# COLORADO DIVISION OF RECLAMATION, MINING AND SAFETY COAL PROGRAM INSPECTION REPORT

Permit Number: C-1981-038 Mine Name: Bowie No. 1 Mine Operator: Bowie Resources, LLC Operator Address: Mr Basil Bear P.O. Box 1488	County: Delta Operation Type: Underground Permit Status: Active Ownership: Federal Operator Representative Present:	
Paonia, CO 81428	Operator Representative Present.	
1 aoma, CO 01420	None Present	
Operator Representative Signature: (Field Issuance Only)

Inspection Start Date: August 22, Inspection Start Time: 08:40 Inspection End Date: August 22, Inspection End Time: 12:30			Inspection Type: Coal Partial Inspection Inspection Reason: Normal I&E Program Weather: Clear	
Joint Inspection Agency: Jo		Joint	<b>Inspection Contacts:</b>	
None				
Post Inspection Agency:		Post	Post Inspection Contacts:	
None				
Inspector(s):	Inspector's Signature: Signature Date:			
Susan L. Burgmaier	Swarlbugman 08/23/2013

Photo 7 Repaired upper Ditch 7

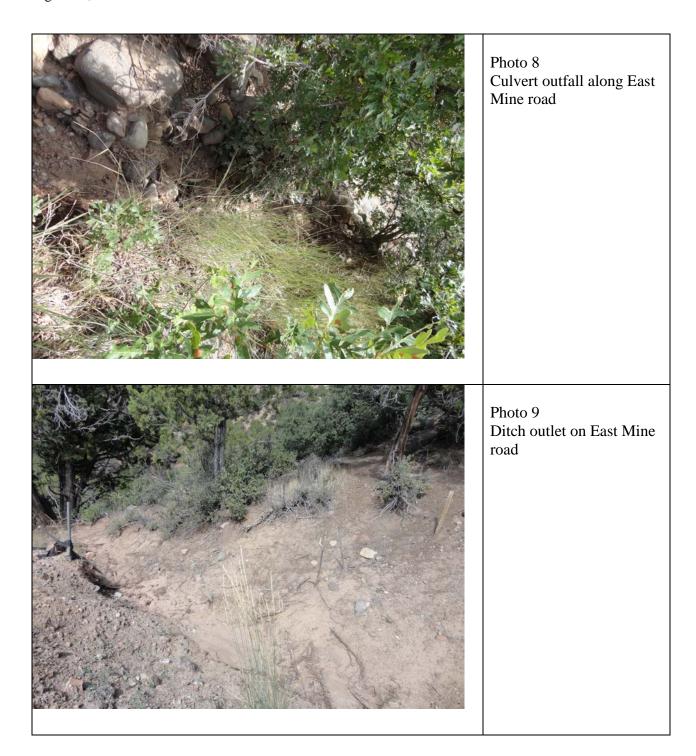
Ditch 7, on the east side of the East Mine, was partially blown out with the recent storm activity, but had been fully reconstructed at the time of the inspection. There were small gullies at the base of the reclaimed crushing bench outslope, where braided flow from the Ditch 7 blowout made its way down to Pond 2. The channel above

Ditch 7, from the former fan bench to Ditch 7 was in excellent condition and did not appear to have been damaged by the recent events.

Photo 14 Silt fence on Stevens Gulch at ROM area

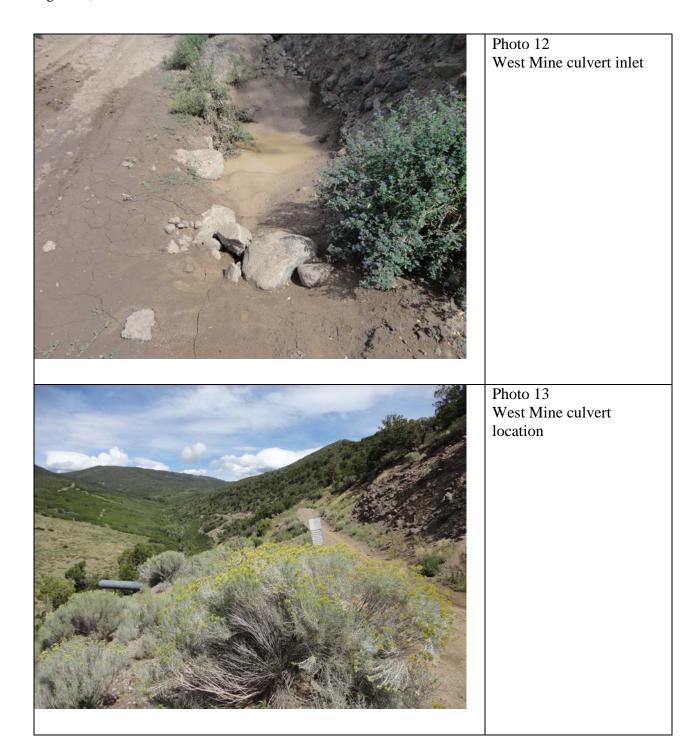
The silt fence along Stevens Gulch, at the ROM area, needs to be replaced. Alternatively, BRL can submit a revision to the permit to allow for alternate sediment control measures (straw wattles, vegetative filter, etc.) along the disturbance, or provide a demonstration that vegetation is adequate to control erosion and sedimentation. Repairs, replacement, or a demonstration need to be completed by October 31, 2013.
